10 January 2022

BLM Office Renovations
Pearl Public School District – Pearl, MS

ADDENDUM NO. 01

1 Floor DEMO PLAN
1/8" = 1'-0"

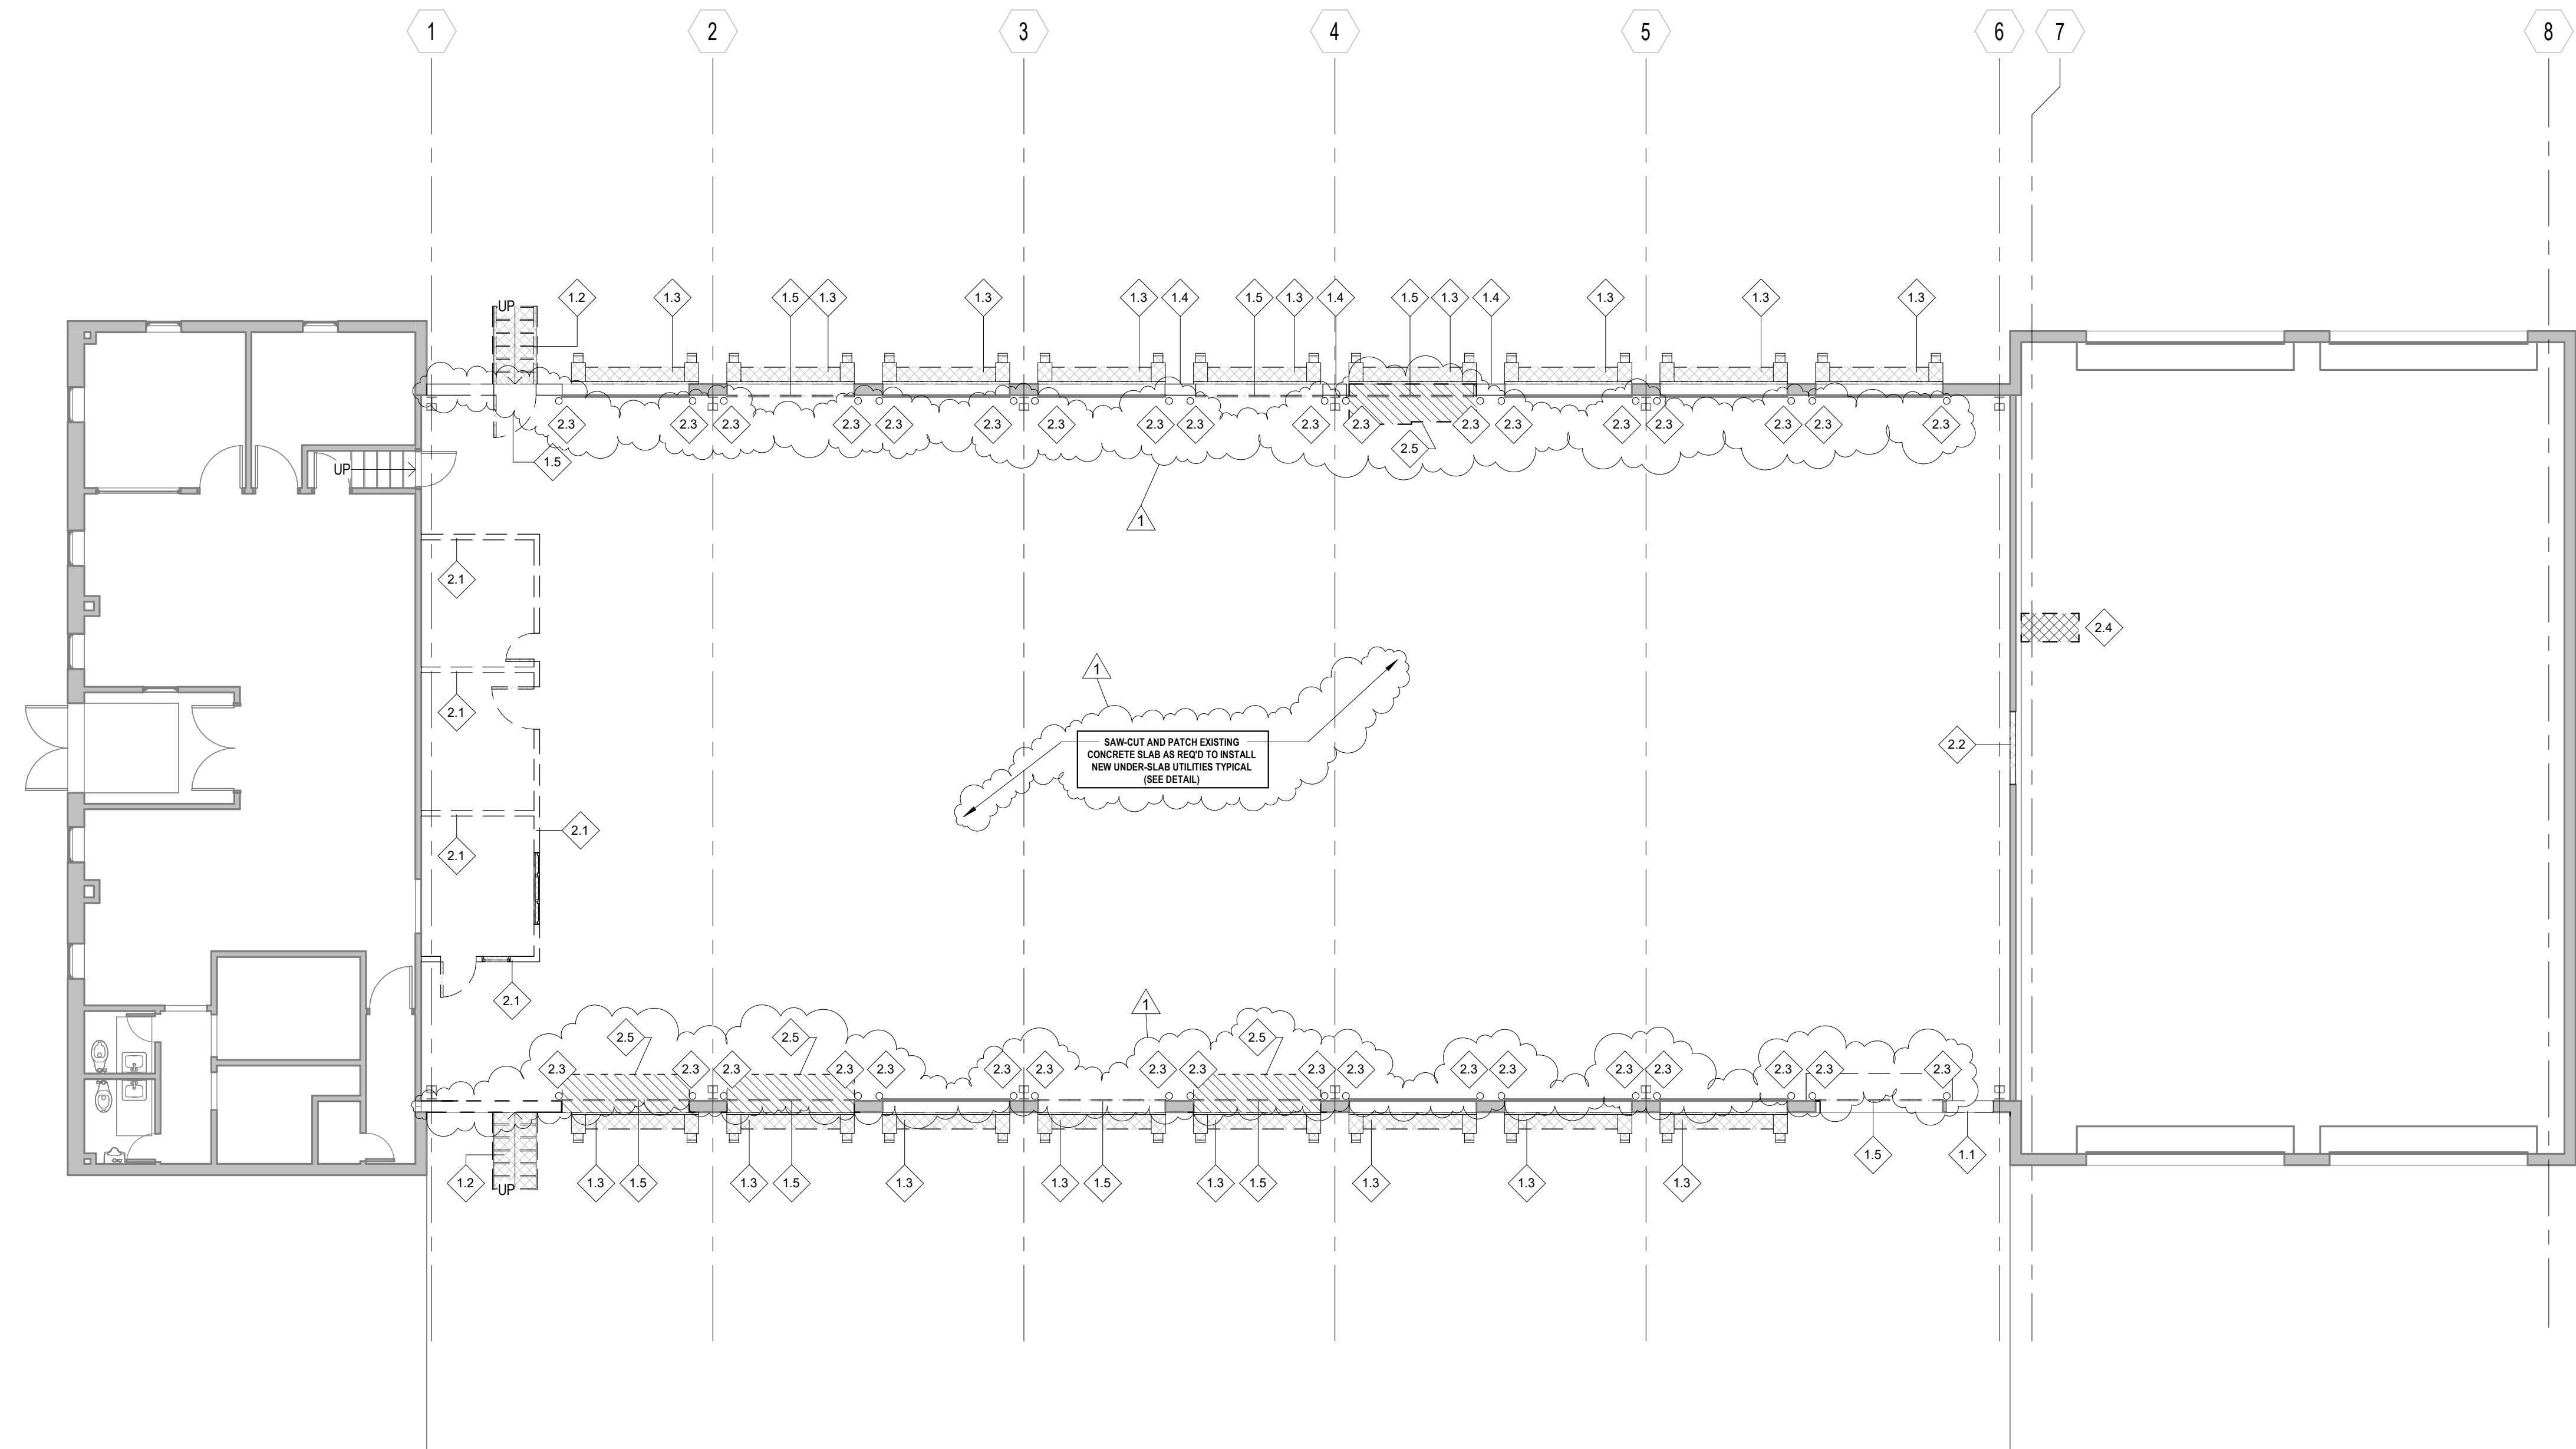
| ITEM NO. 5 | <p>D100 DEMO PLAN</p> <p>Revise per the enclosed sheet.</p> |

A101
FIRST FLOOR PLAN

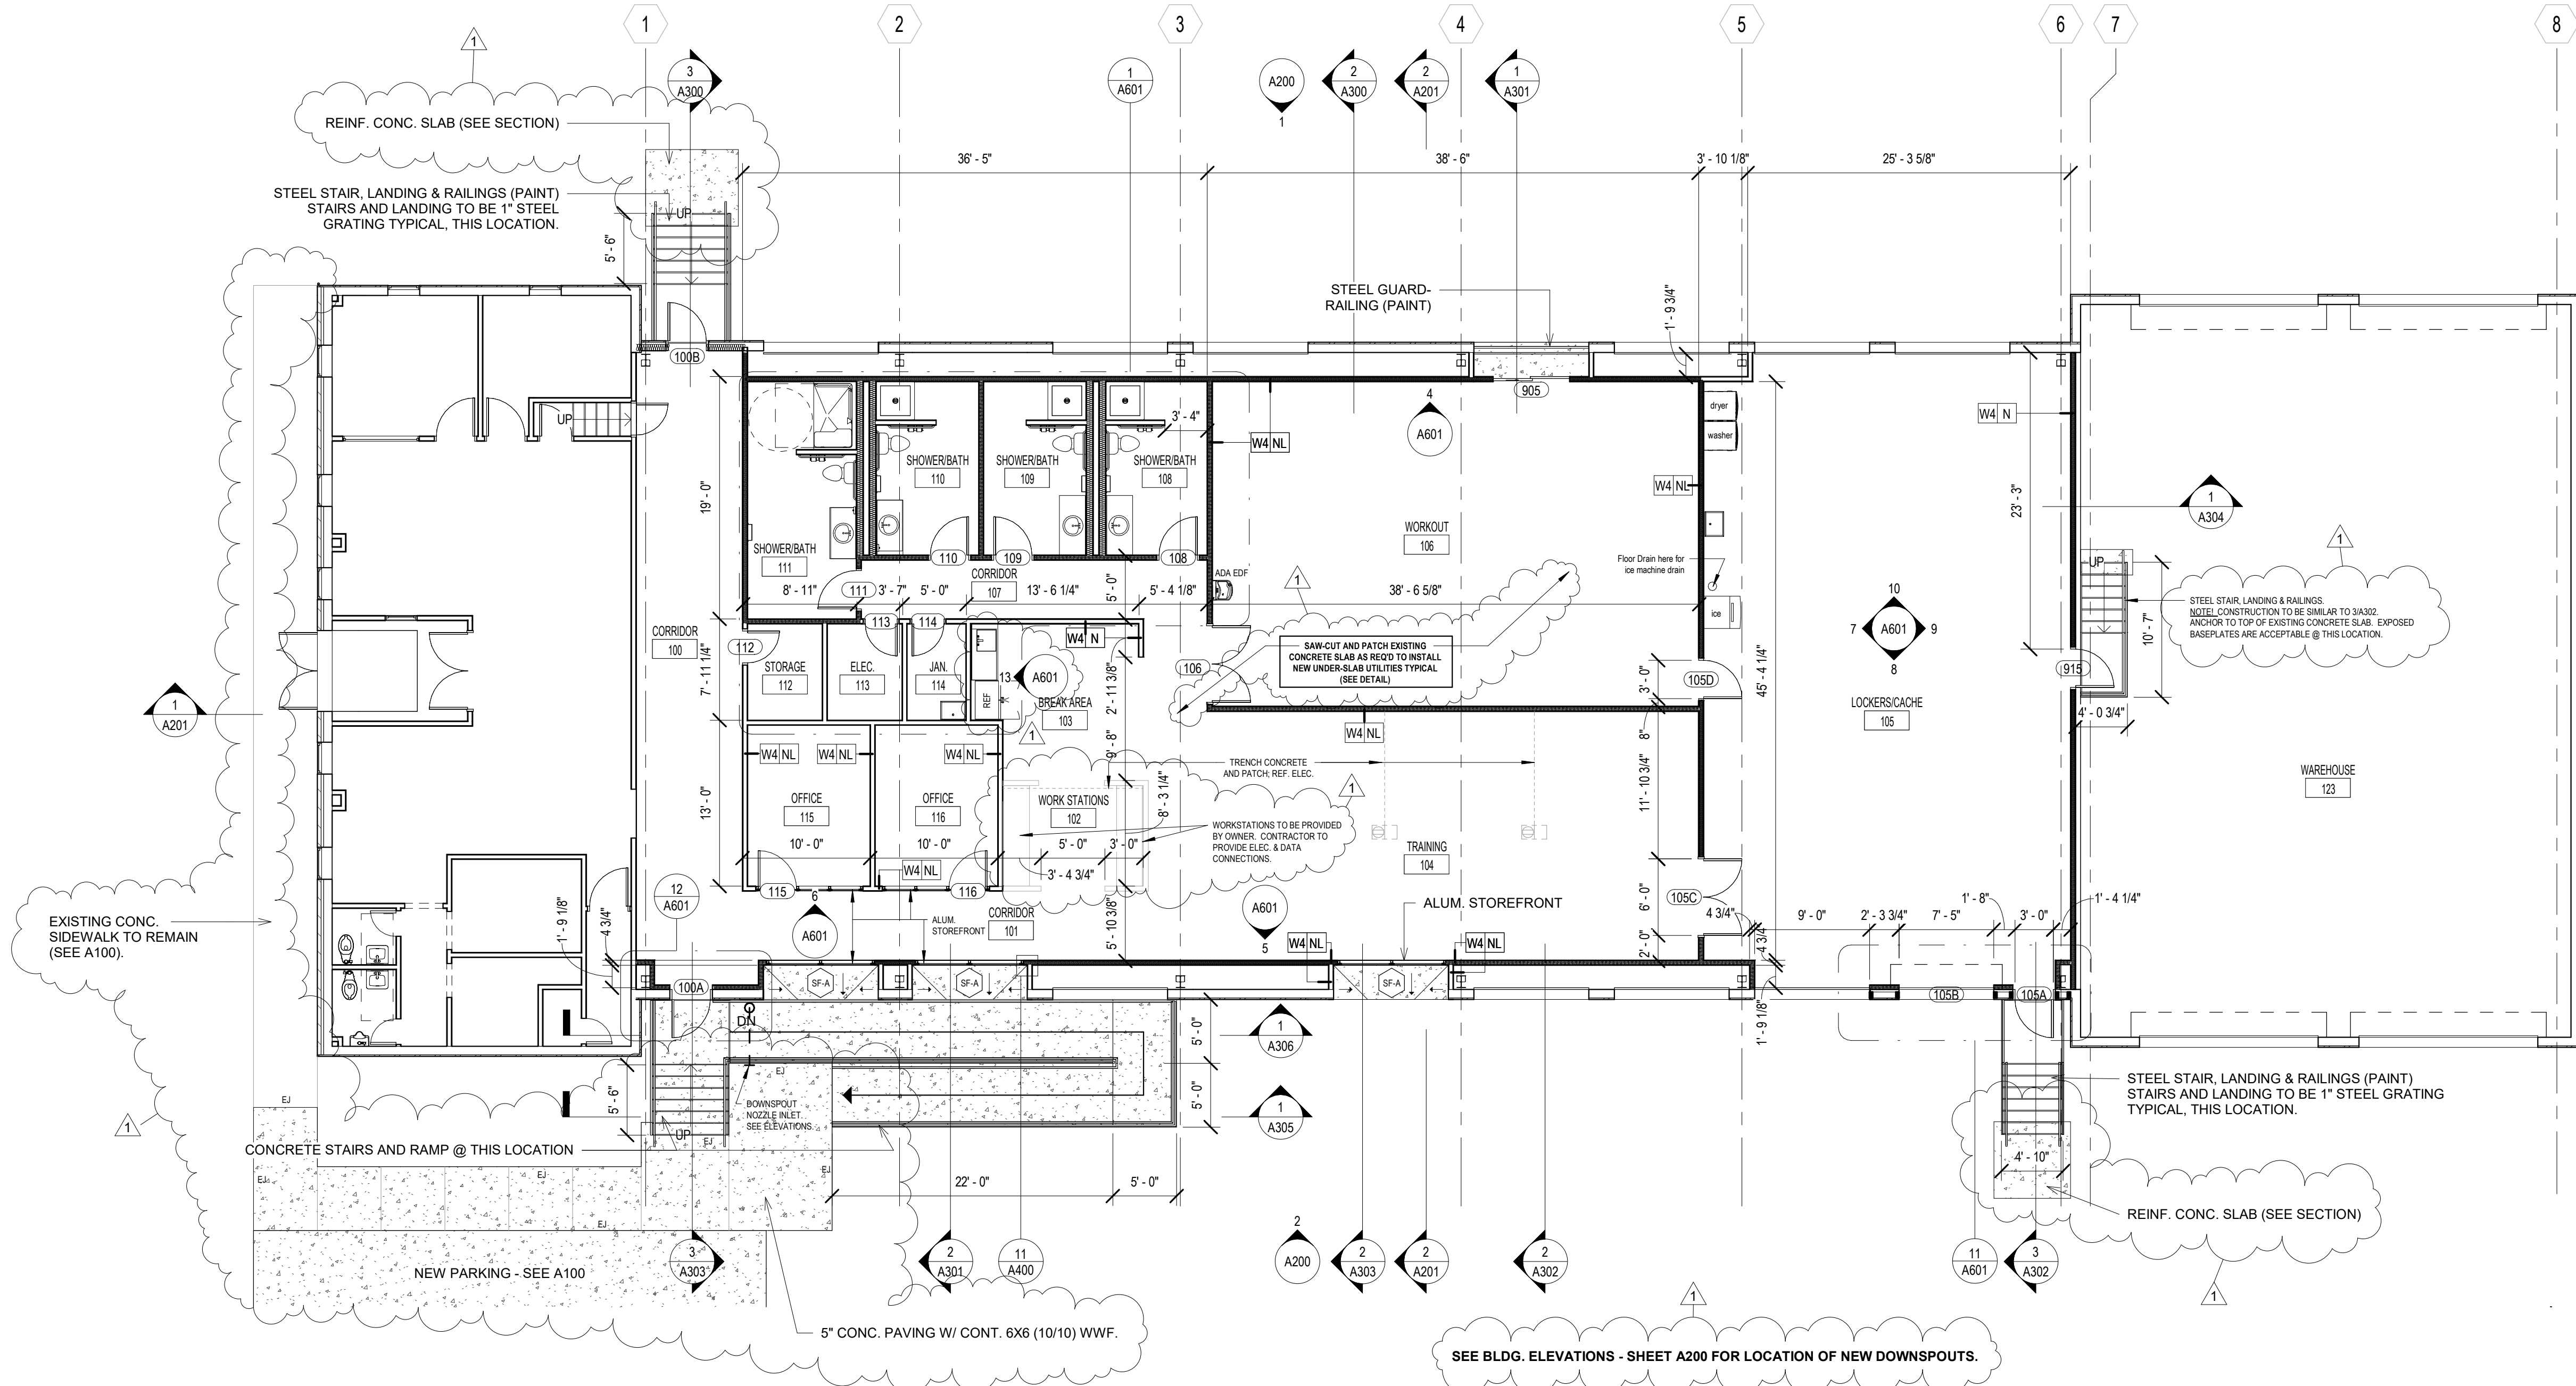
| ITEM NO. 7 | <p>A101 FIRST FLOOR PLAN</p> <p>A103 FINISH PLAN</p> <p>Revise per the enclosed sheets.</p> |

1 EAST ELEVATION
1/8" = 1'-0"

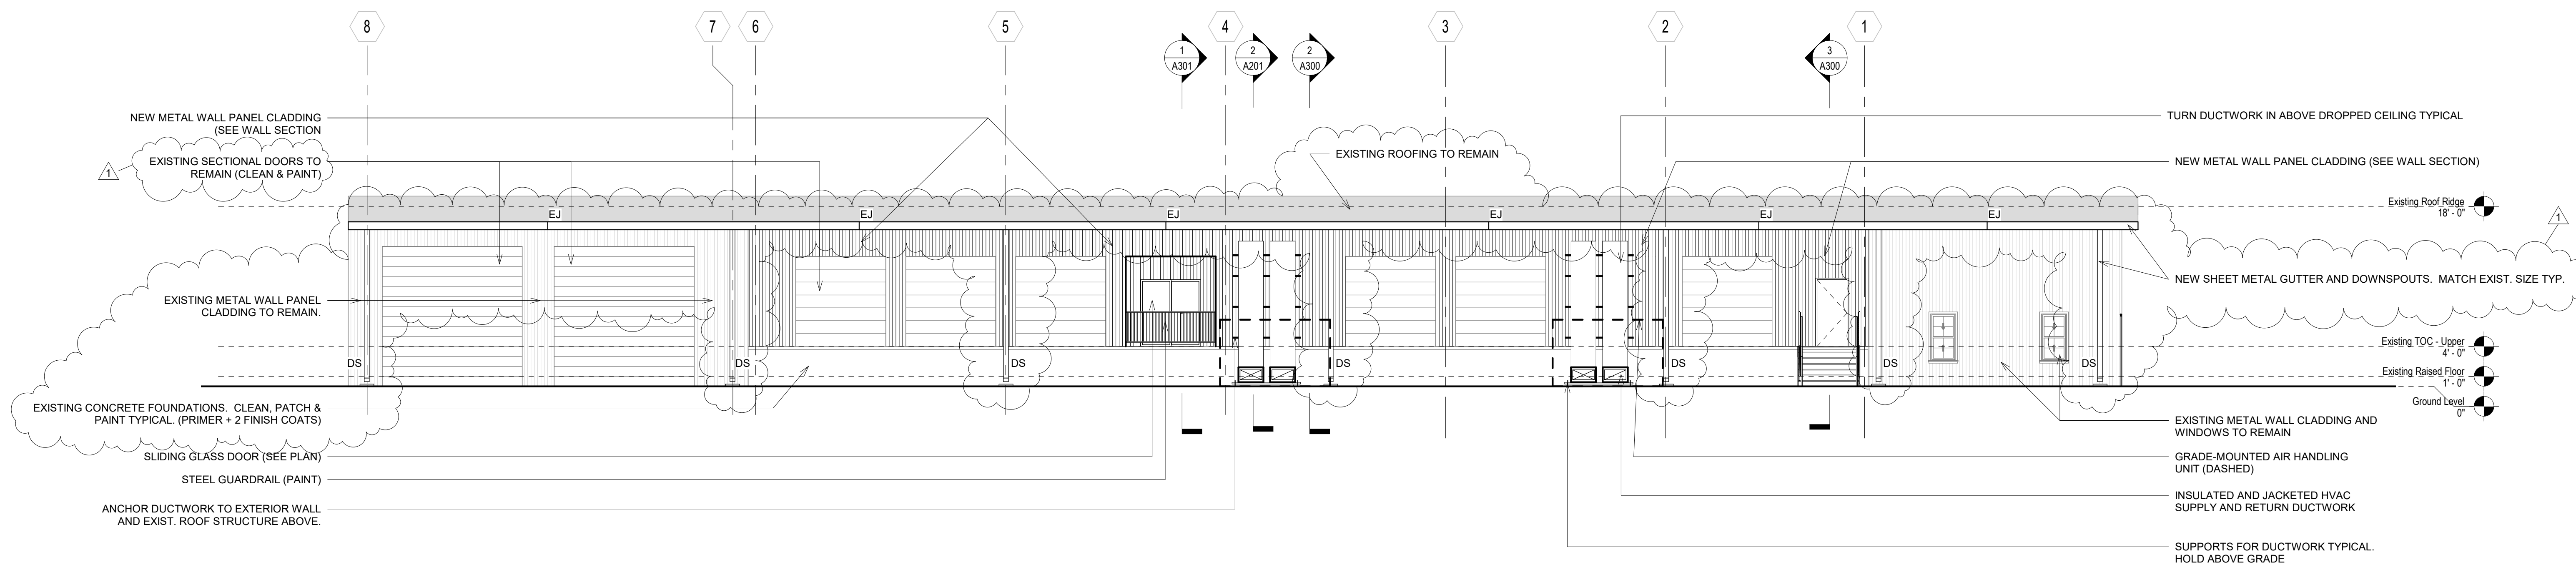
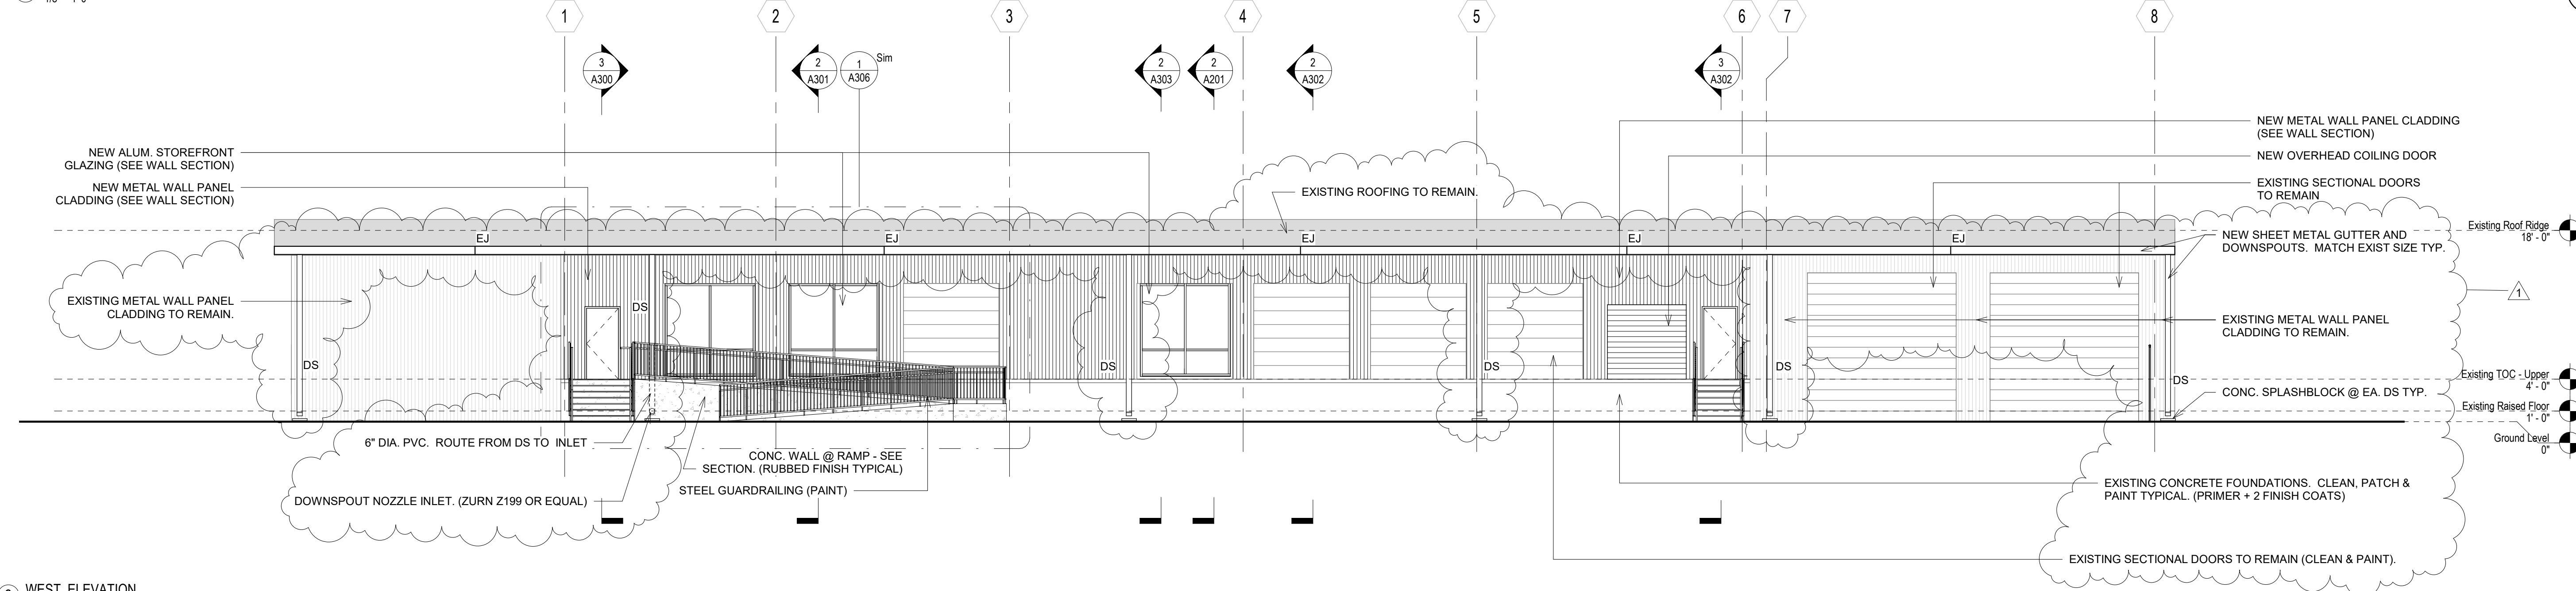
| ITEM NO. 8 | <p>A200 EXTERIOR ELEVATIONS</p> <p>Revise per the enclosed sheet.</p> |
